### 3.5 Missile Protection

STP DEP 3.5-1 (Table 3.5-1 and Figure 3.5-2)

STP DEP 3.5-2

Figure 3.5-2 Low-Trajectory Turbine Missile Ejection Zone

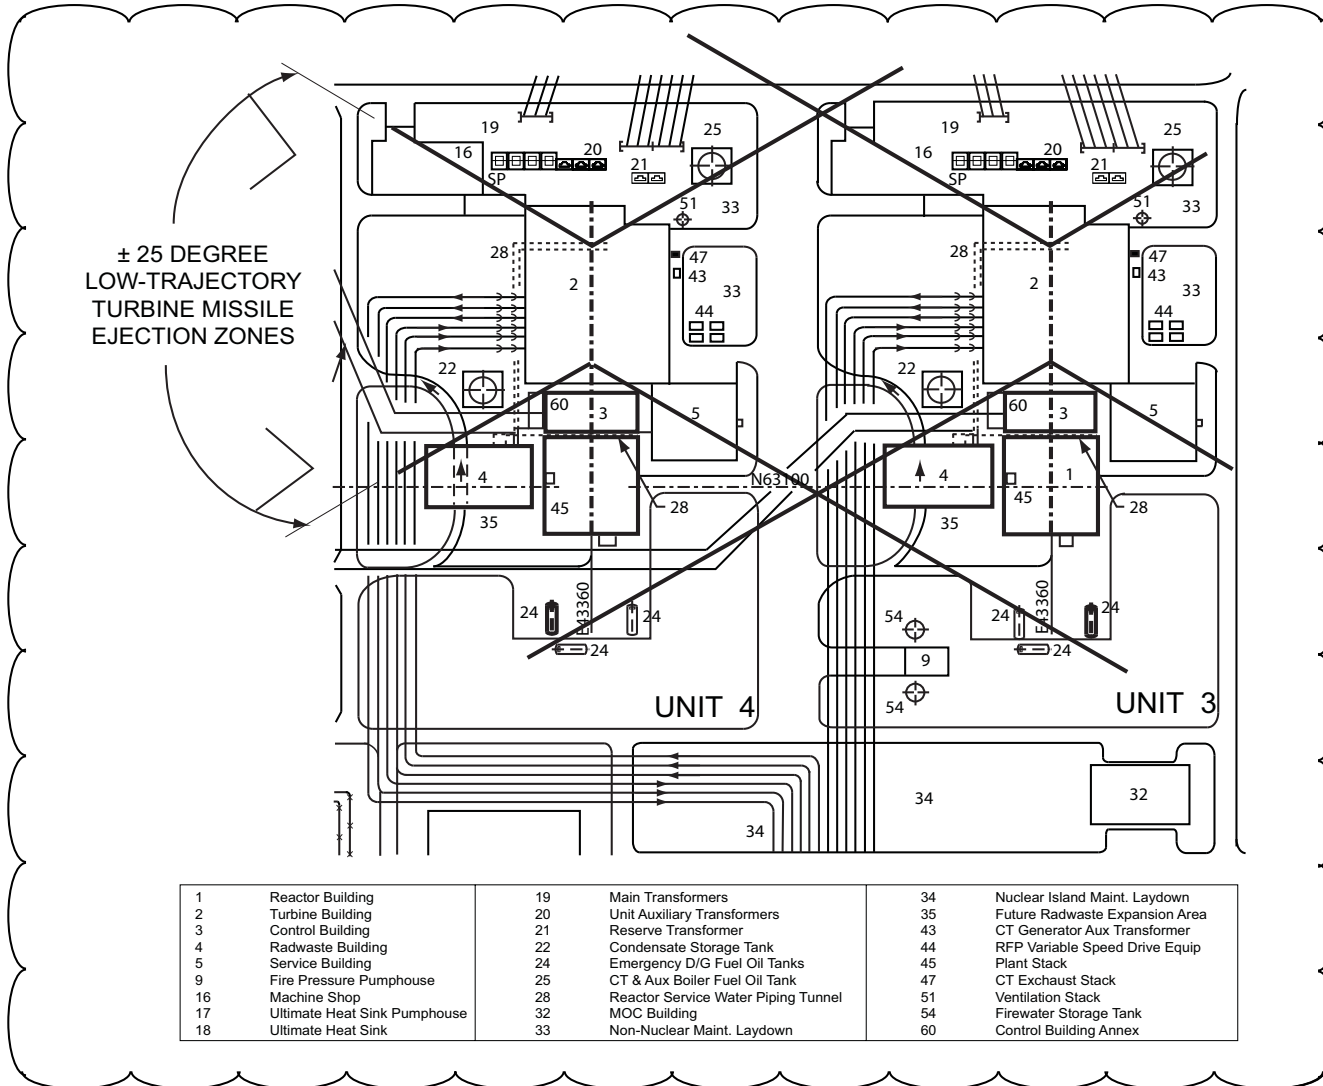
The STP 3 & 4 turbine generator placement and orientation in relation to essential systems of the adjoining unit are illustrated on Figure 3.5-2. Per Regulatory Guide 1.115, the STP 3 & 4 turbine generator placement and orientation is considered unfavorable. Per Acceptance Criteria 1 of Standard Review Plan Section 3.5.1.3 for unfavorable turbine generators, a value of  $10^{-2}$  per year per plant was chosen as a conservative value for the product of strike probability ( $P_2$ ) and damage probability ( $P_3$ ). The criteria for unfavorable turbine generator orientation given in Standard Review Plan Table 3.5.1.3-1 and provided in Table 3.5-1 was assumed for the missile generation probability ( $P_1$ ). The resulting probability of unacceptable damage from a main steam turbine missile ( $P_4$ ), which is  $P_1 \times P_2 \times P_3$ , is less than  $10^{-7}$  per year per plant.

Therefore STP 3 & 4 main steam turbine generator placement and orientation meets the acceptance criteria of Standard Review Plan 3.5.1.3 and the guidelines of Regulatory Guide 1.115.
